**DESIGN, CONSTRUCTION AND CONSTRUCTION SUPPORT SERVICES
FOR THE REHABILITATION OF THE NORTHBOUND AND SOUTHBOUND
BRUCKNER EXPRESSWAY BRIDGES OVER CSX AND AMTRAK**

**CONTRACT No. HBX1123
PIN 84107BXBR171**

Addendum # 4

December 27, 2007

CATENARY CLEARANCE DIMENSIONS

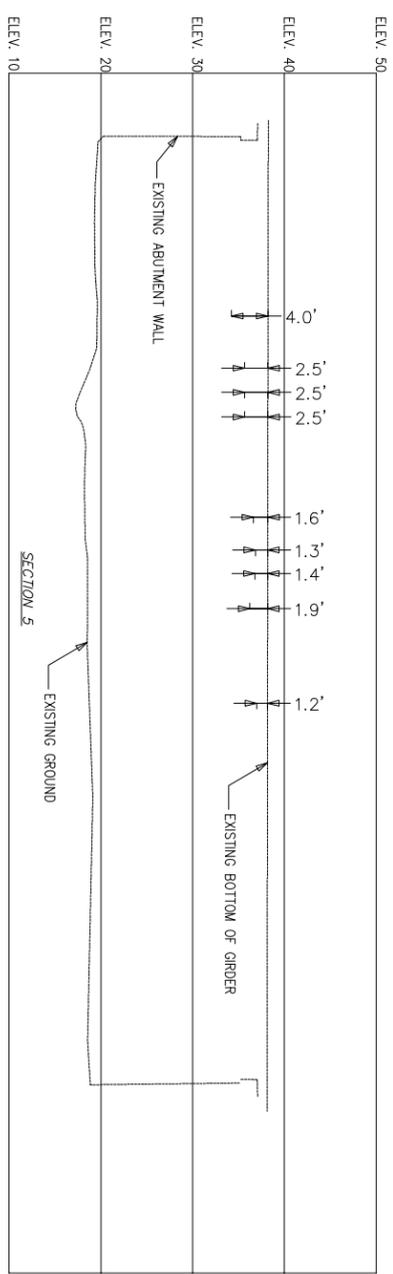
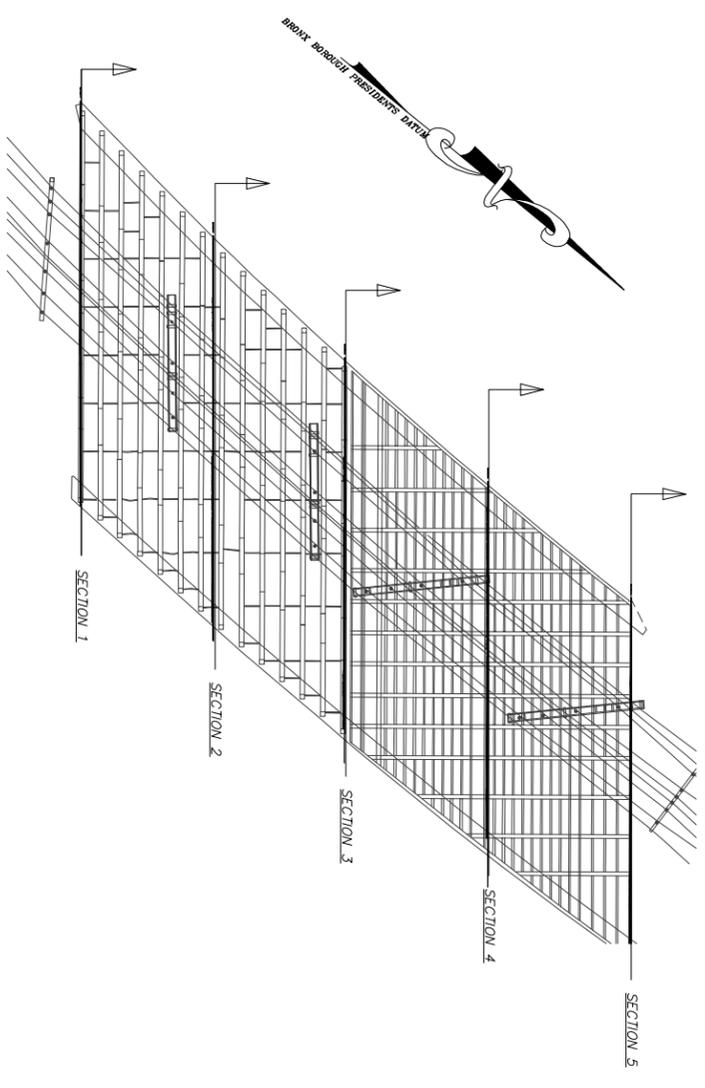
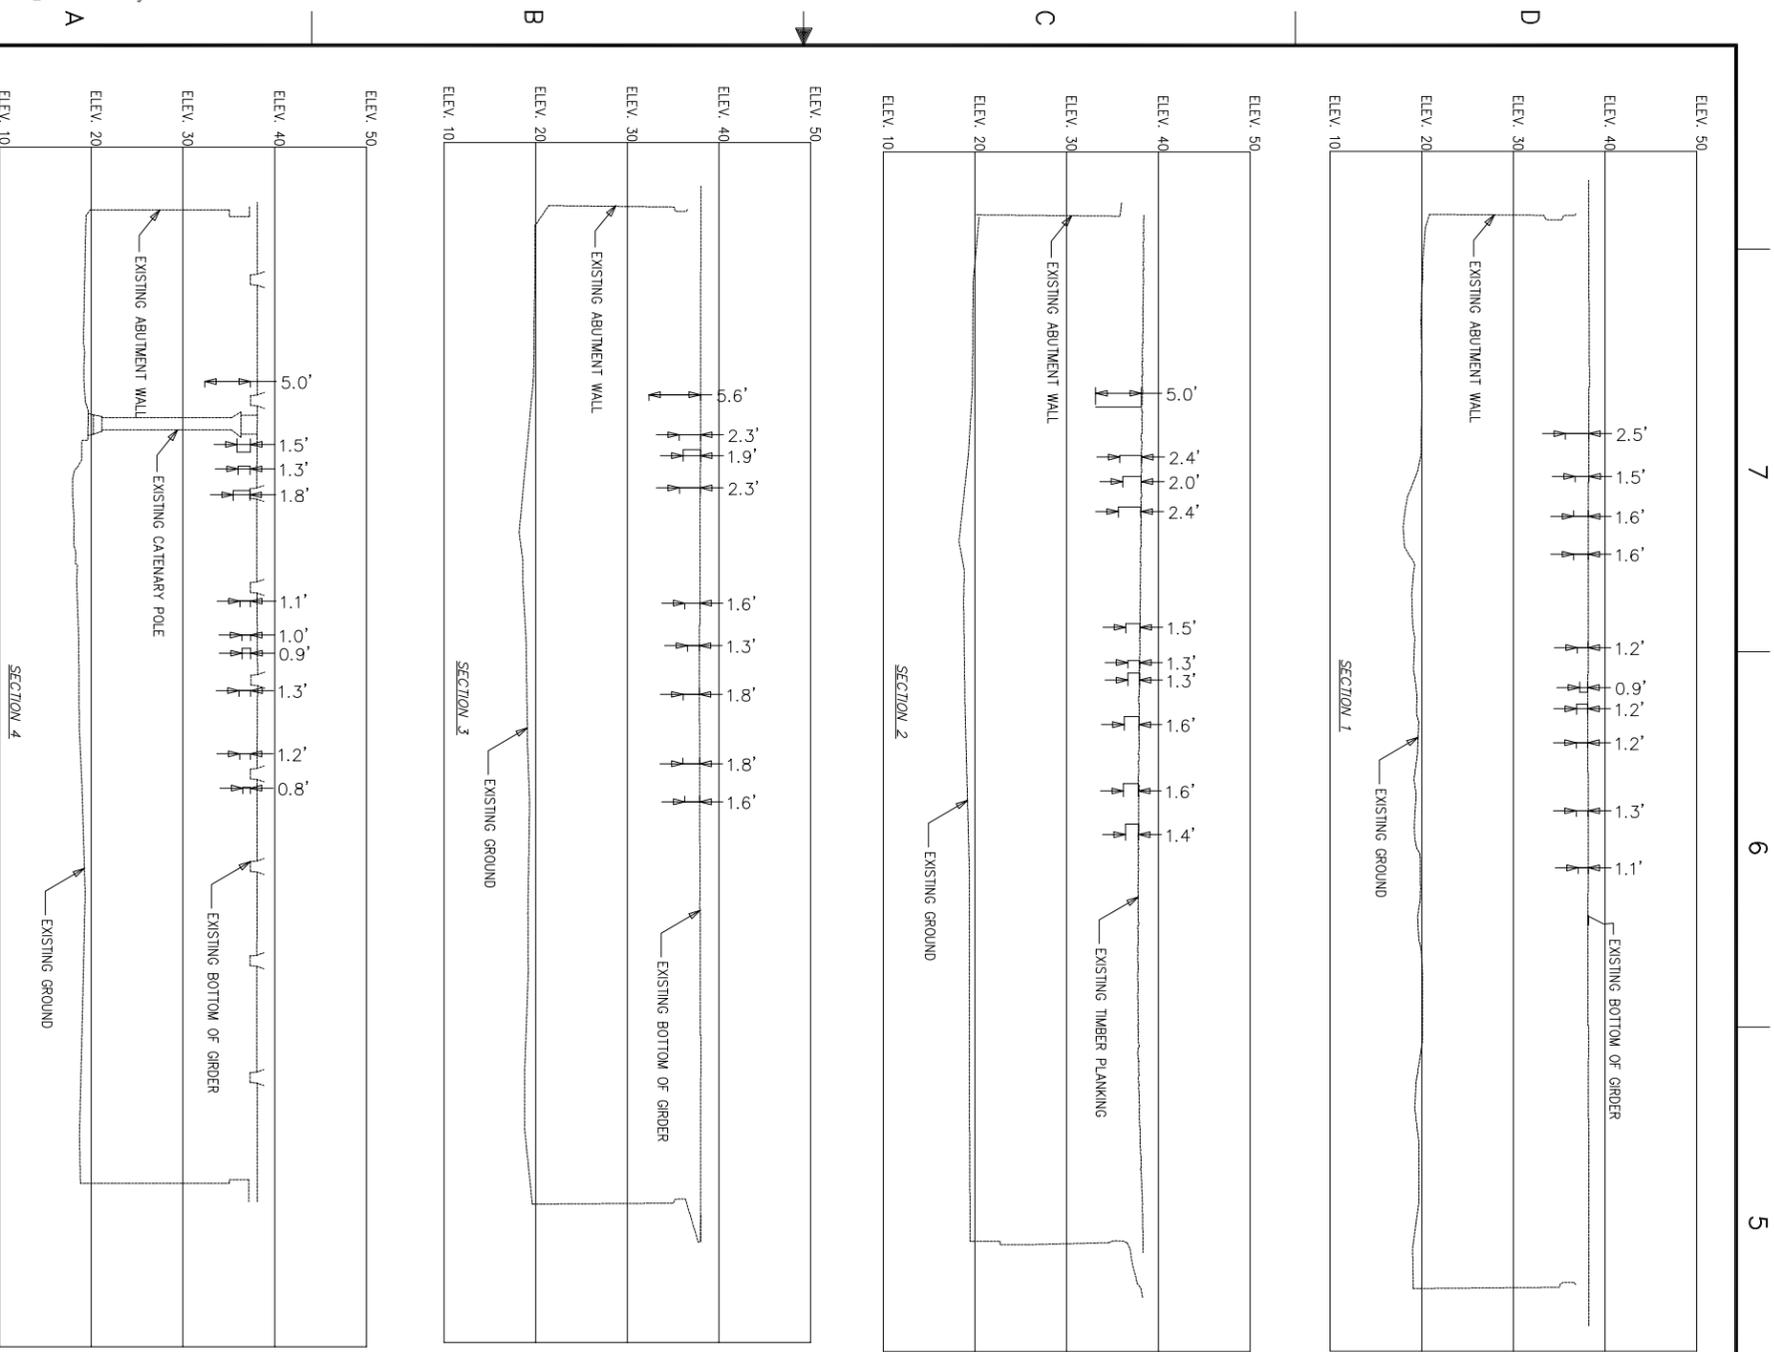
Question 34: We wish to confirm that when Amtrak states that they will provide single or double track outages that both catenaries will be de-energized during the entire length of the outage.

Clarification: Assume that both catenaries will be de-energized at the same time.
